ENGAGEMENT REPORT

Mixed Use Development comprising a Hotel, Commercial Office Premises and a Residential Flat Building

No. 2-4 Burleigh Street and No. 20-24 Railway Parade,

REF: M230306

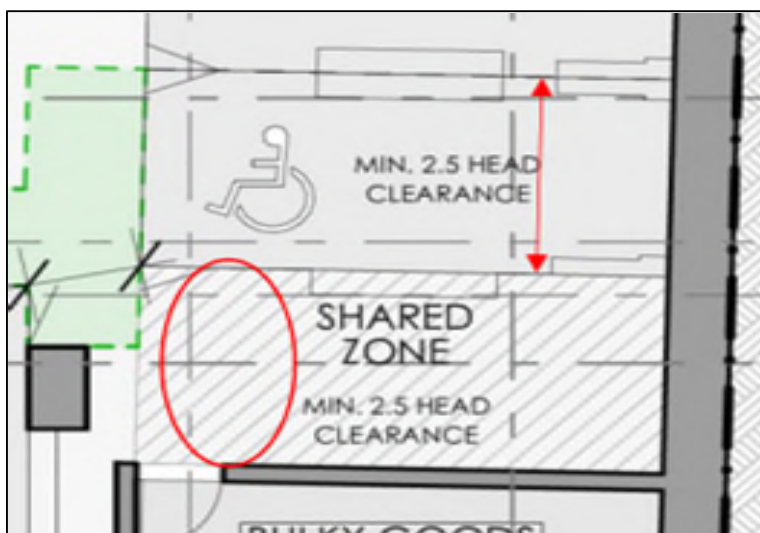
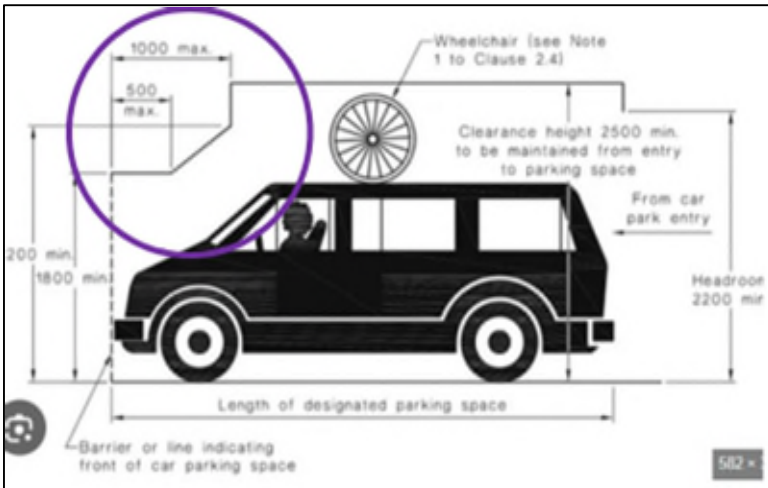
Design drawings SK08 P24, SK09 P24 and SK10 P24 do not show bollards in the shared space adjoining the accessible parking (allocated) space. In addition, dimensions are not shown for the accessible parking spaces (across all basement levels).

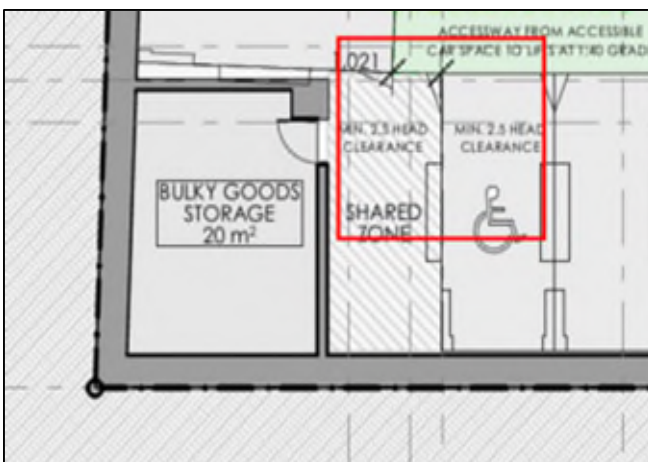
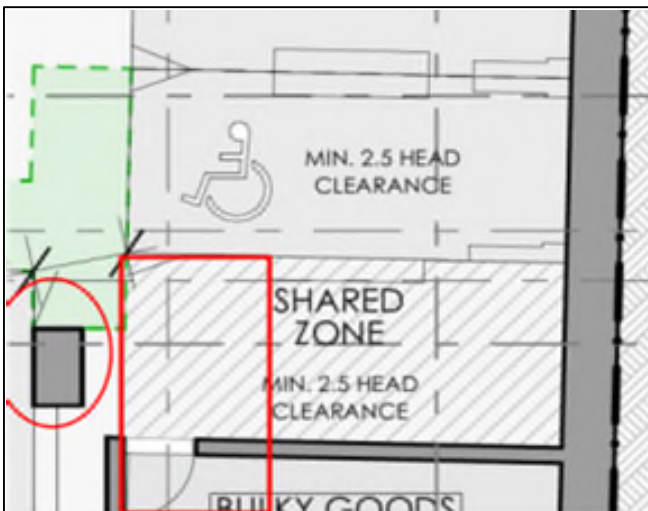
On drawing SK10 P24, there appears to be a substation pit above the accessible parking space. Recommendation for services designer/engineer to consider relocation of this pit. Otherwise, the construction of this space must be in accordance with AS2890.6-2022 – car parking spaces for disabilities

The construction of shared spaces must be designed to ensure that there are no impediments or encroachments into the shared spaces. The location of bulky goods and doorways leading into shared spaces can create unintended obstructions for the user of the accessible parking space. There is further obstruction from the location of support pillars (assumed).

In the above screenshot (western end of basement), there is only 1.021m of clearance between the edge of accessible parking space and the edge of adjoining parking space. The length of space and parking angle meant that a big utility vehicle, as is now common in Australia, will not only reduce the 1.02m clearance, and make it difficult to exit shared zone if there is concurrent access to bulky goods storage.

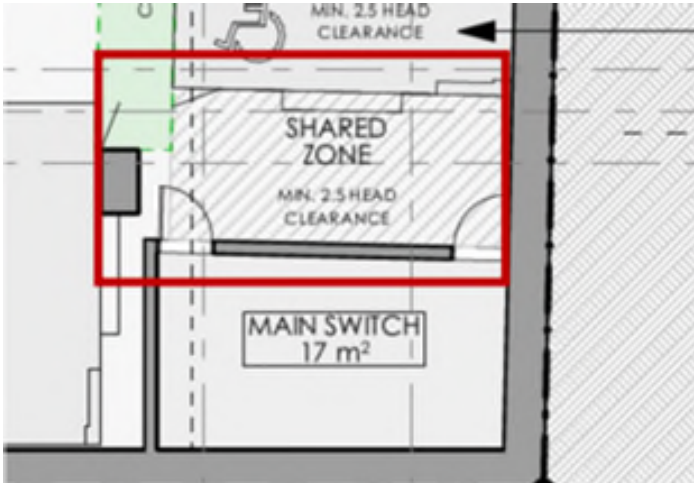
Basement 1-shared space for accessible parking space (eastern end of basement) is adjacent to a main switch room with two outward opening doors. The two doors, and the first door being additional obstruction in close proximity to a support pillar will result in an unknown path of travel for the user exiting shared space.

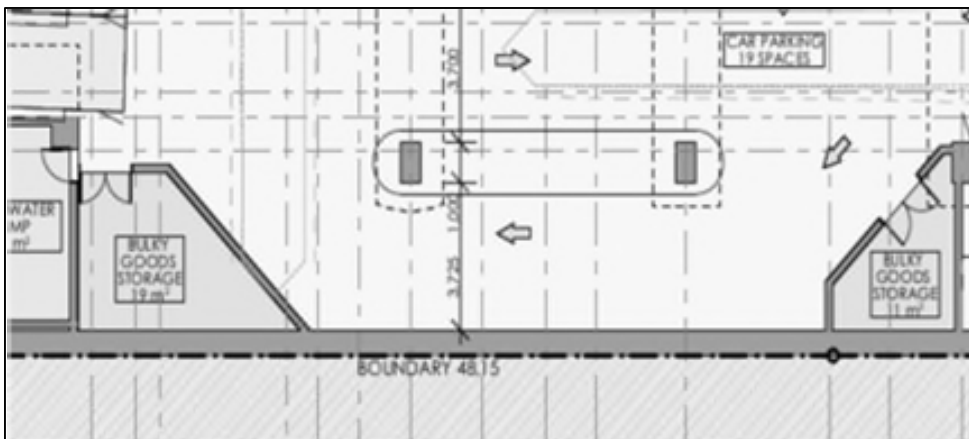
Recommendation: Reconsider locations of all bulky goods storage. Reconsider the siting of doorways to each storage and review the actual door width. The door widths are not compatible with the bulky goods storage – refer to Basement 1 drawing SK10 P24 (below) with double doors exceeding 850mm.

<p>door width. The door widths are not compatible with the bulky goods storage – refer to Basement 1 drawing SK10 P24 (below) with double doors exceeding 850mm.</p> <p>There are other accessibility matters for assessment by the certifier, including but not limited to path of travel accessibility, TGSI – tactile, hearing loop installation, Braille signs and accessibility, ramps, luminance contrast of building surfaces throughout the building, location of adult changing rooms – public if required.</p>	<p>The bulky goods storage has been relocated adjacent the loading dock on ground floor.</p> <p>The proposed development has been designed in coordination with an Access Consultant and has been deemed capable of complying with all access requirements.</p> <p>Further details to as CC stage.</p>
<p><u>Ground Floor</u></p> <p>The ground floor level consists of residential access lobby, hotel and commercial offices lobby and potentially a café (cannot identify location of café from drawing SK11 P24). Certifier to consider appropriate classification of each part of the building, and to make an assessment under NCC 2022 on fire safety.</p> <p>Fire separation for consideration by the certifier – wall between bulk goods storage and the substation. The bulky goods storage (depending on management of access) may contain hazardous goods such as a portable BBQ.</p>	<p>The proposed development has been designed in coordination with a BCA Consultant & Fire Engineer and has been deemed capable of complying with all NCC requirements.</p> <p>The design of the hotel/ commercial lobby and café will be detailed at a CC Stage. This is left as an open space and will be determined by each specific hotel operator’s requirements.</p> <p>Further details to will be provided at CC stage.</p> <p>The substation will be designed to Austgrid requirements.</p> <p>The proposed development has been designed in coordination with a BCA Consultant & Fire Engineer and has been deemed capable of complying with all NCC requirements.</p> <p>Further details to will be provided at CC stage.</p>

Ground Floor

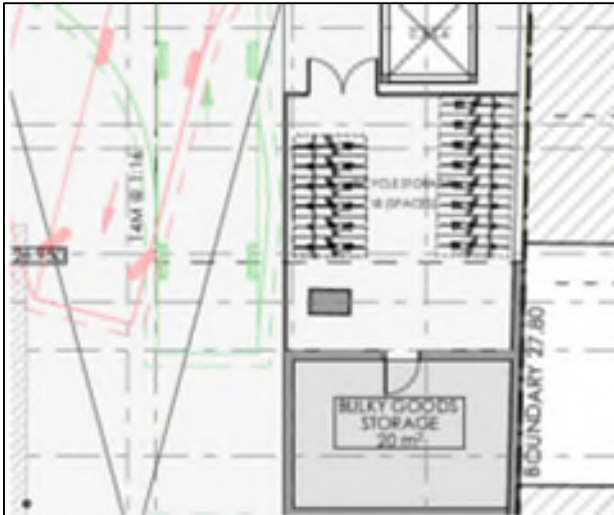
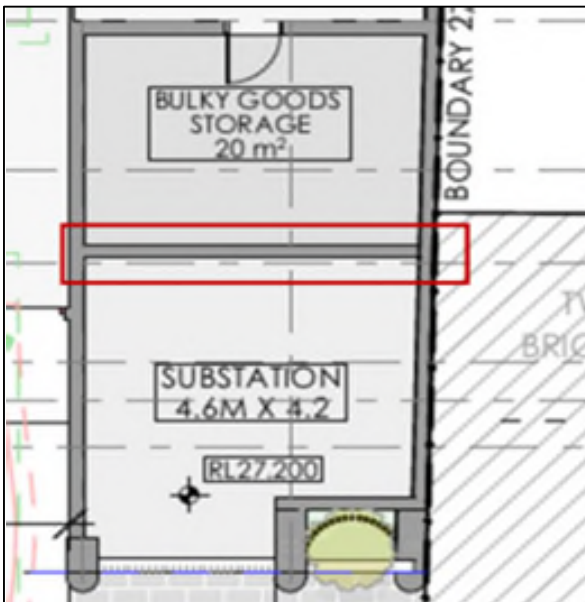
The ground floor level consists of residential access lobby, hotel and commercial offices lobby and potentially a café (cannot identify location of café from drawing SK11 P24). Certifier to consider appropriate classification of each part of the building, and to make an assessment under NCC 2022 on fire safety.

Fire separation for consideration by the certifier – wall between bulk goods storage and the substation. The bulky goods storage (depending on management of access) may contain hazardous goods such as a portable BBQ.

Fire Separation Between Floor Levels

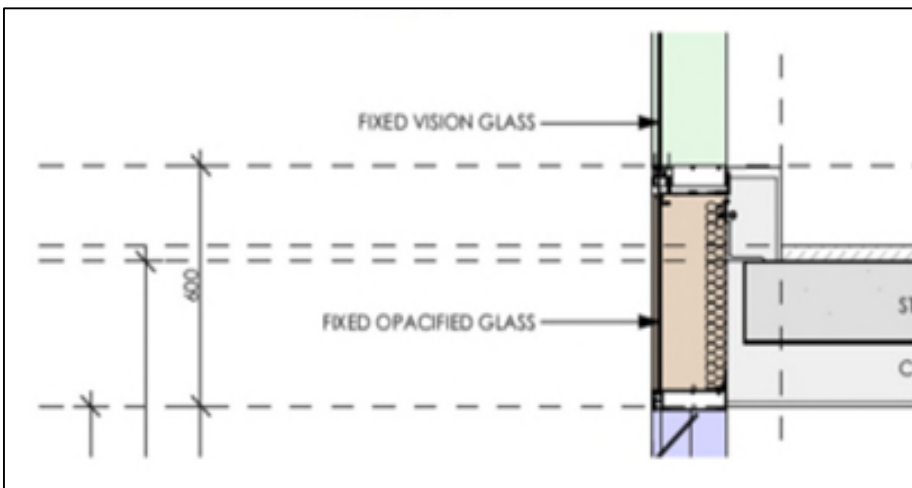
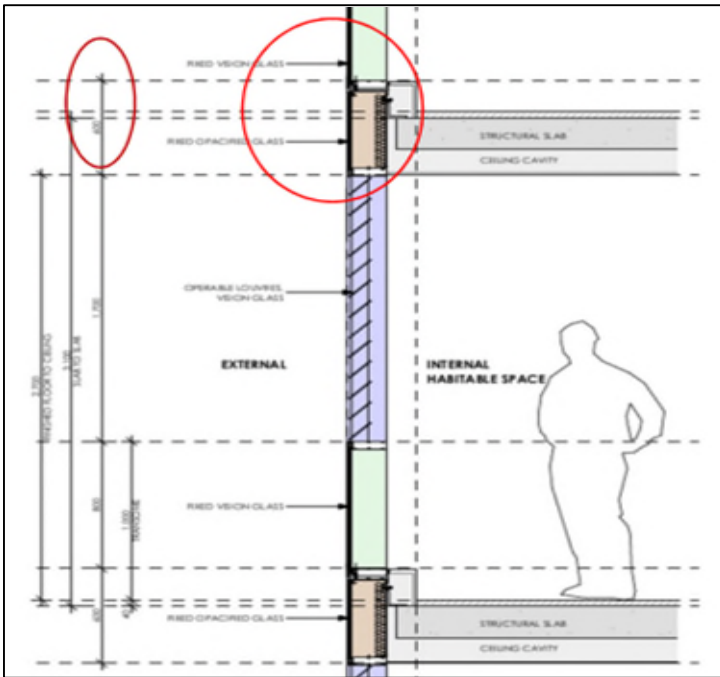
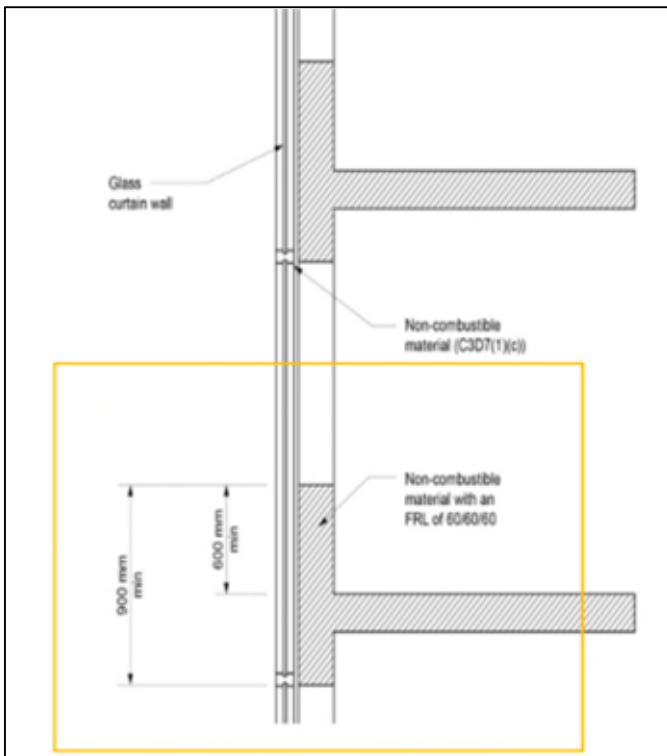
Notwithstanding Council's concerns with glazed façade, inadequate design details for the curtain walls are shown. Specifically:

Minimum design considerations as per NCC 2022 Volume 1 for the application of spandrels, or curtain walls that are utilized for this proposed development.

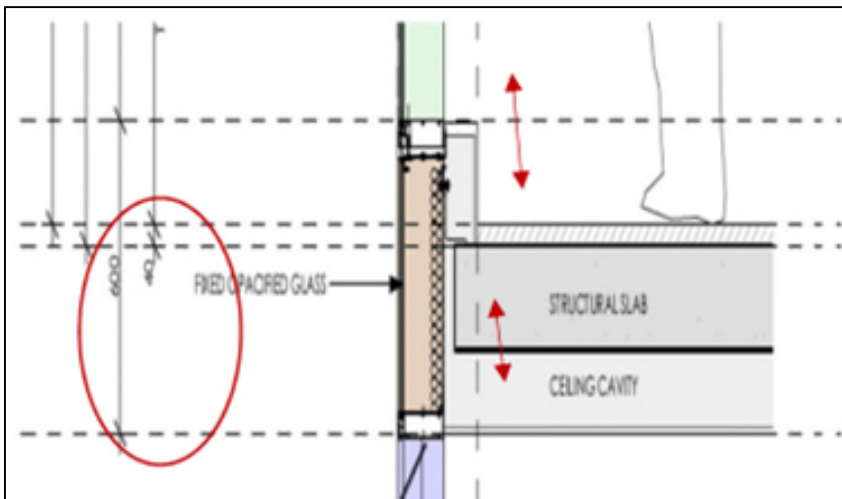
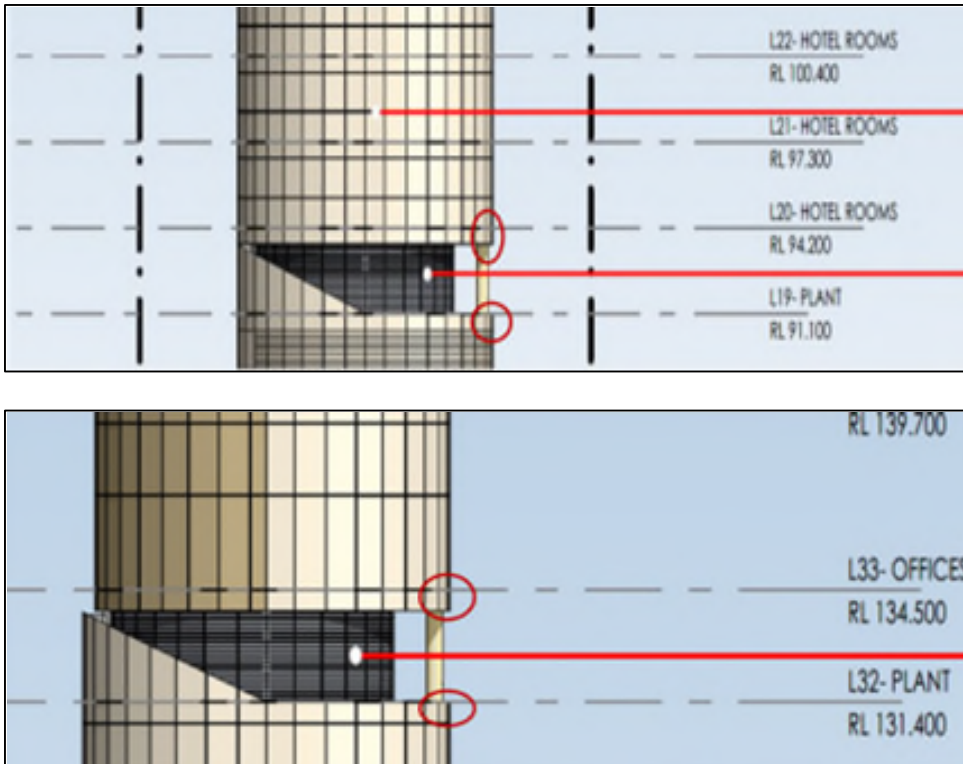
Separation of external window openings to prevent spread of fire between levels must cover 900mm, with 600mm at minimum from the edge of floor above. Red arrows are critical information gaps where it is unknown how this curtain wall design will achieve compliance, or a performance solution warranted for the proposal.

The transome is 1000mm, and fixed vision glass is 800mm. Subtracting the fixed vision glass from transom leaves 200mm. **200mm of opacified glass, fixings and 40mm of flooring meant that the curtain wall construction has vertical protection (assumed) to 240mm.**

This meant 360mm of the minimum 600mm vertical protection is non-compliant.

There is no detail whether the material behind fixed opaque glass is non-combustible, including the structural slab and extent of fire resistance for those materials shown.
